U. S. COAST AND GEODETIC SURVEY

DESCRIPTIVE REPORT

Field No. LY-4246 Office No. H-7127

Locality ISLE OF SHOALS

CROSSING DISCREPANCIES

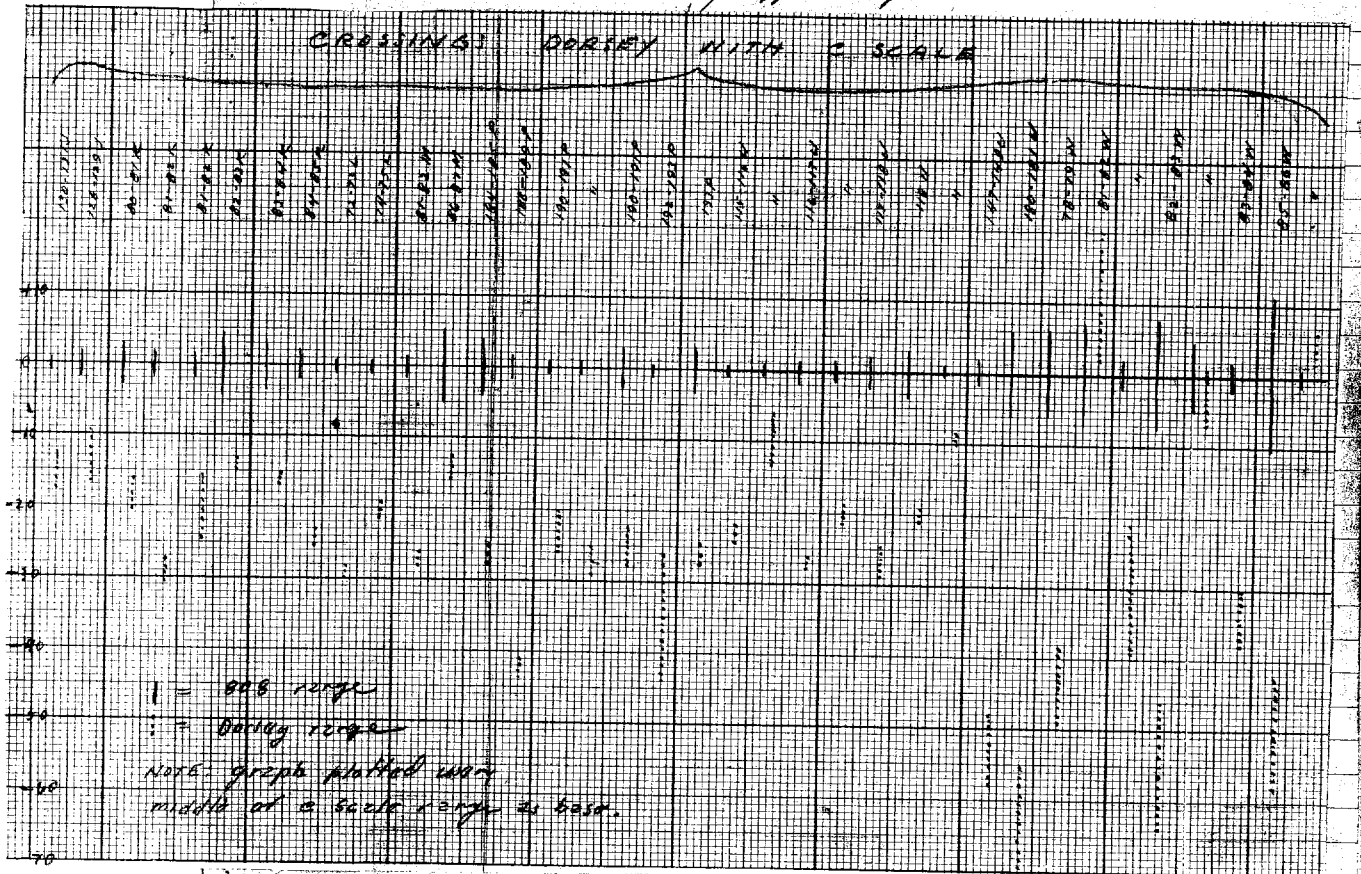
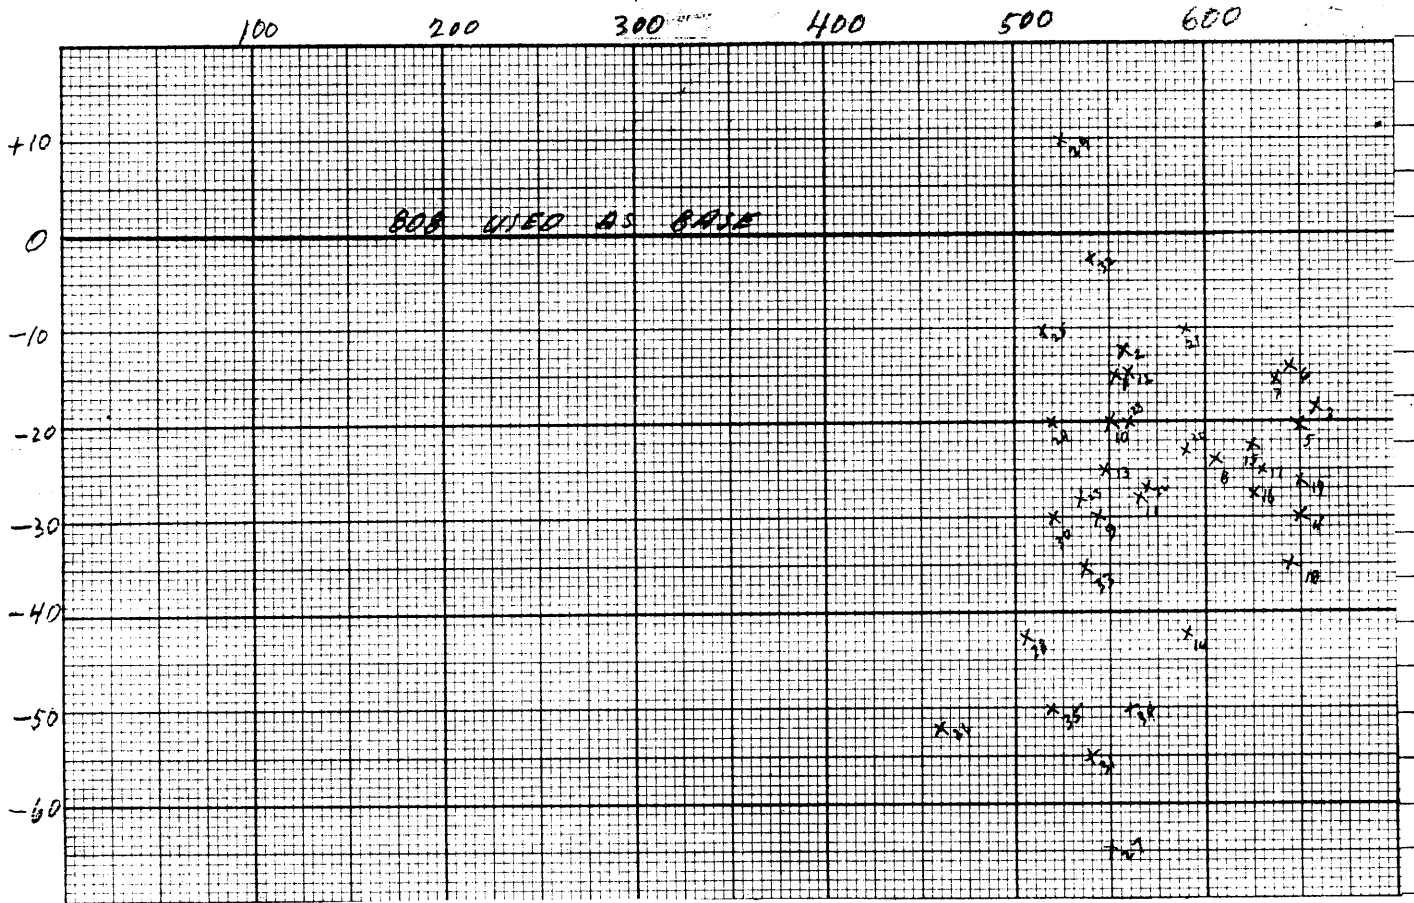
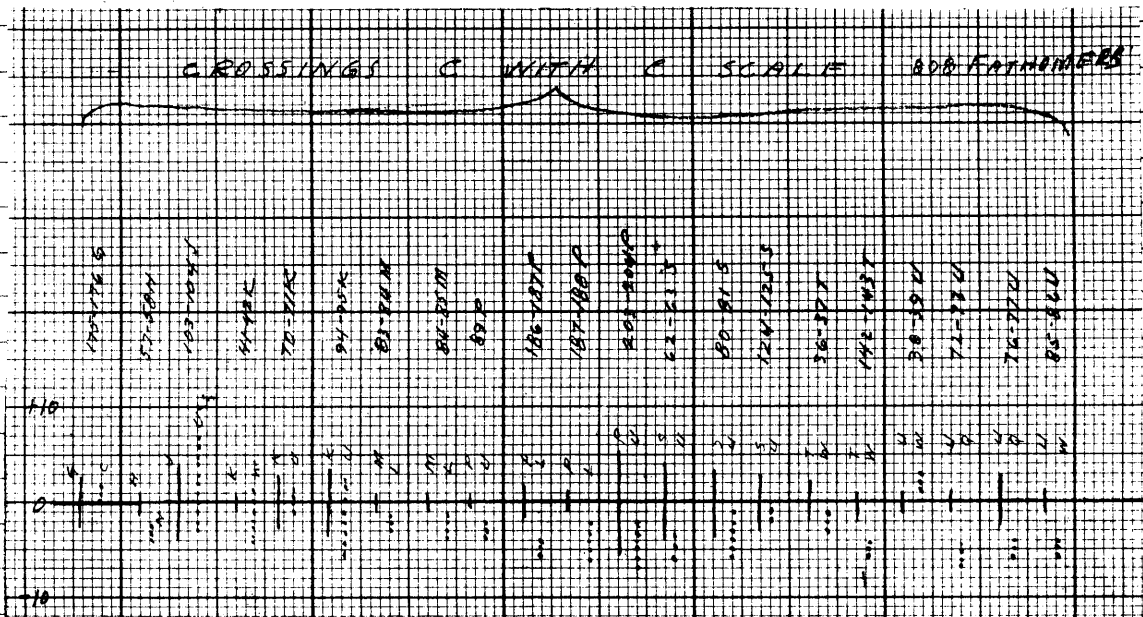
The graph below shows the extent of conflict in the sounding lines at crossings, as mentioned in the Processing Office report.

The graph on the next page was plotted from the same values, but the differences are plotted at respective depths.

The following graph shows the agreement that may be expected in these depths.

## PHASING

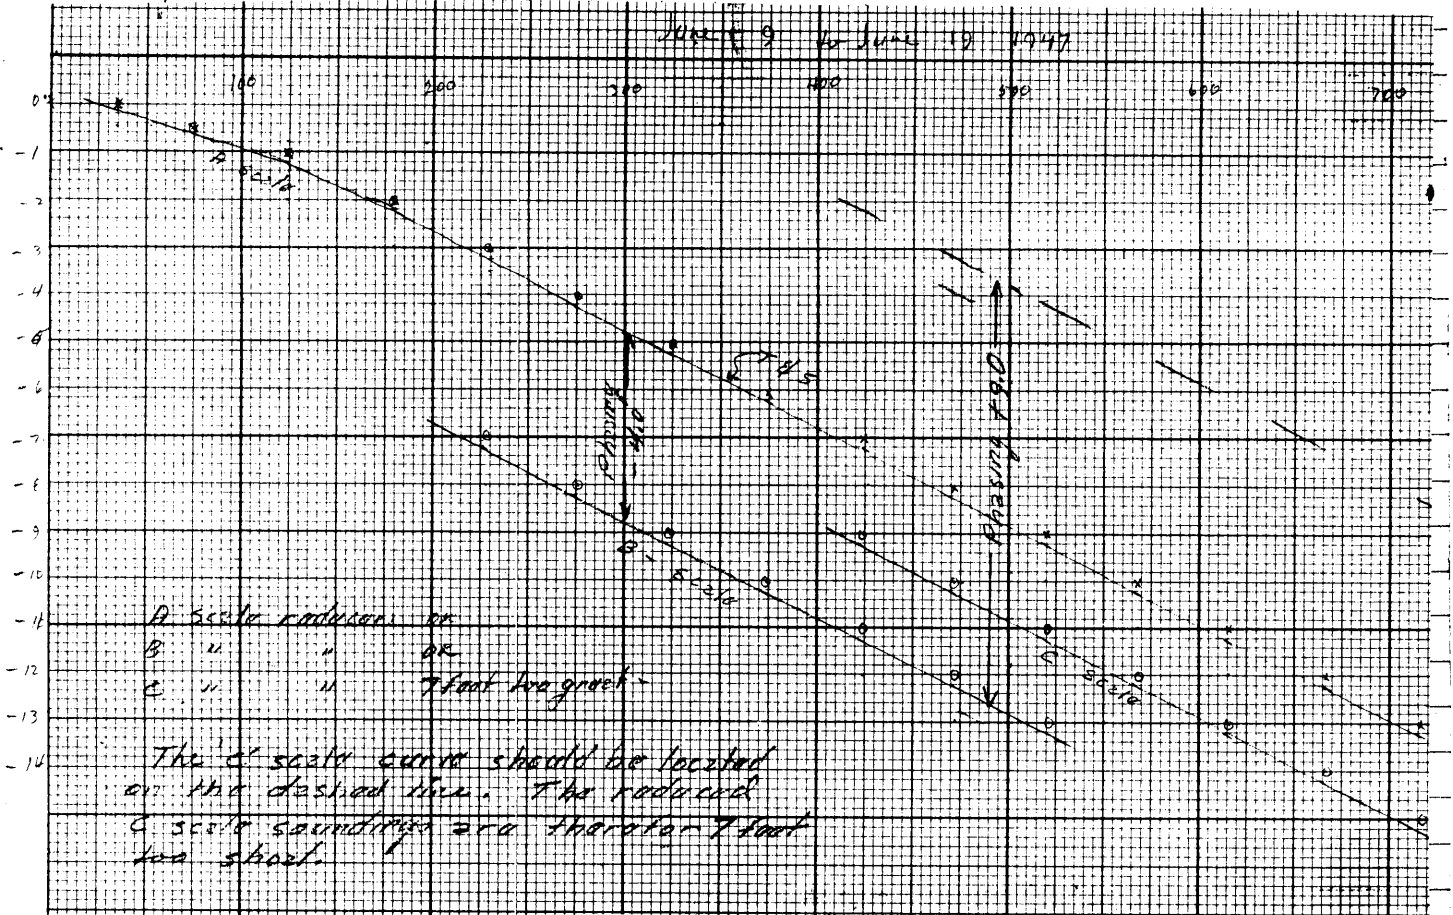
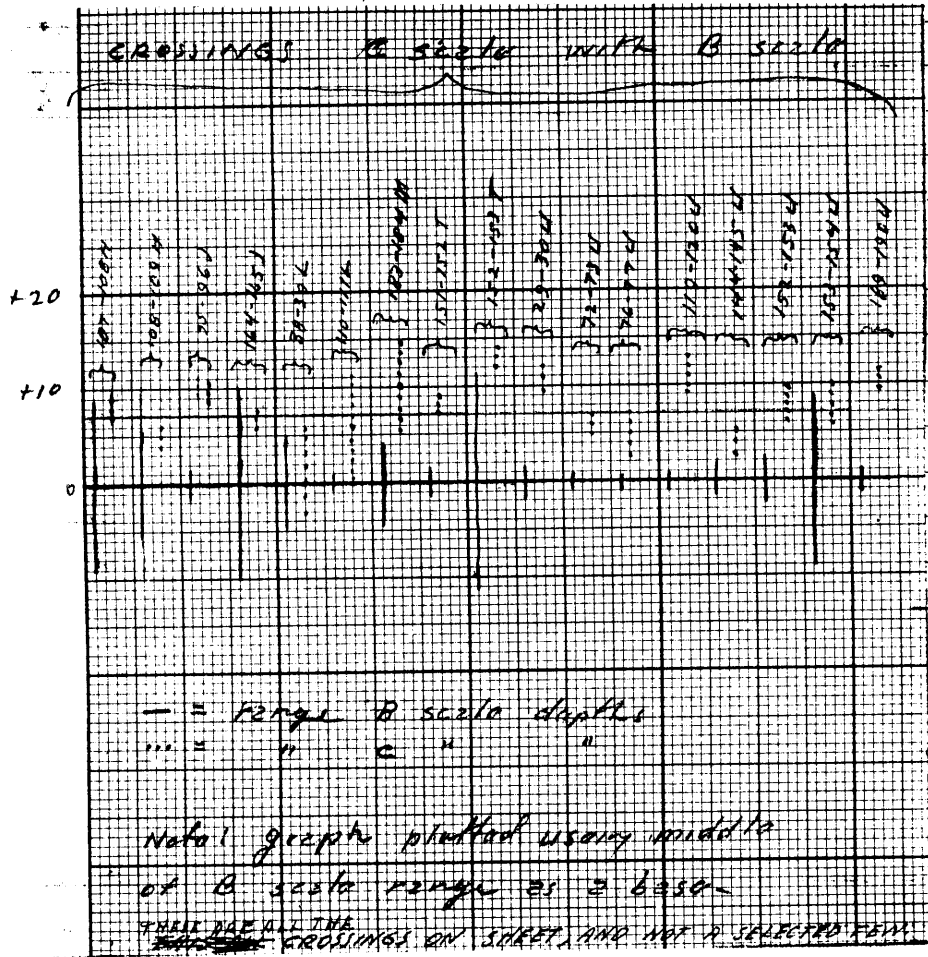
As the bathograms show a difference of +2.0 feet in going from "B" to "C" scales, the correction of +2.0 feet used in the reducers is to be questioned.

In order to test the need for the addition of +7.0 feet to the soundings of the "C" scale, two sets of comparisons were made.

1. Comparison with Dorsey soundings at phase change: About a fourth of the values obtained indicated that a +7.0 ft. correction was needed. Another fourth indicated that no correction was necessary, and the remaining

half were too erratic to use. Therefore nothing conclusive could be proved by comparison with Dorsey soundings.

2. Comparison of "C" scale crossings with "B" scale: This definitely indicates that a plus correction of about 7.0 feet is needed to bring "C" scale soundings into the plane of "B" scale.

The +2.0 used in reducers originated from a comparison made Sept. 7, 1947 (H-7140), one month after completing and four months after starting H-7127.

The verifier applied corrections phase corrections as seemed proper, based on individual conditions.
